# UNITED STATES PATENT AND TRADEMARK OFFICE

### Office Action Summary

10/817,125

## **DETAILED ACTION**

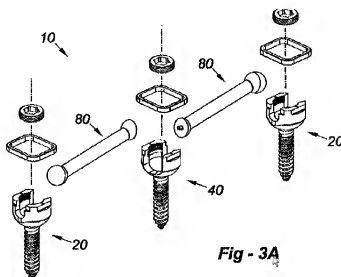
Ferree disclose a spinal apparatus having a rod with at least one bulbous end (Fig. 36), and an end with a convex end facing the inboard side of an end (see below)
